Project	IEEE 802.16 Broadband Wireless Access Working Group < http://ieee802.org/16 >	
Title	Enhancement for MIMO Transmission with 3 Antennas	
Date Submitted	2004-08-17	
Source:	Wen Tong, Peiyong Zhu, Ming Jia, Dongsheng Yu, Jianglei Ma, Mo-Han Fong, Hang Zhang, Brian Johnson Nortel Networks 3500 Carling Avenue Ottawa, ON. K2H 8E9 CANADA	Voice: (613)-763-1315 Fax: (613)-765-7723 wentong@nortelnetworks.com
Re:	Response to Recirculation Ballot #14c	
Abstract	The enhancement of the 3-antenna MIMO transmission	
Purpose	To incorporate the changes here proposed into the 802.16e D5 draft.	
Notice	This document has been prepared to assist IEEE 802.16. It is offered as a basis for discussion and is not binding on the contributing individual(s) or organization(s). The material in this document is subject to change in form and content after further study. The contributor(s) reserve(s) the right to add, amend or withdraw material contained herein.

Enhancement for MIMO Transmission with 3 Antennas

Figure 1 sub-carrier mapping

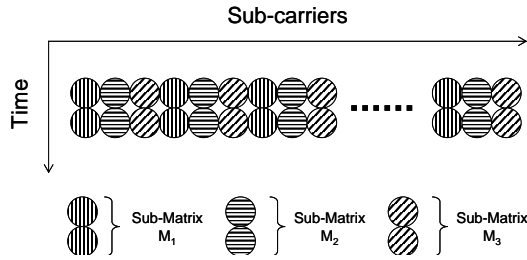
1.3 Mapping of the Matrix-A/B

Since the matrix A and matrix B share the same dimension, i.e. $Matrix - A/B = [M_1 \quad M_2 \quad M_3]$

The sub-carrier mapping can be designed as shown in Figure 1.
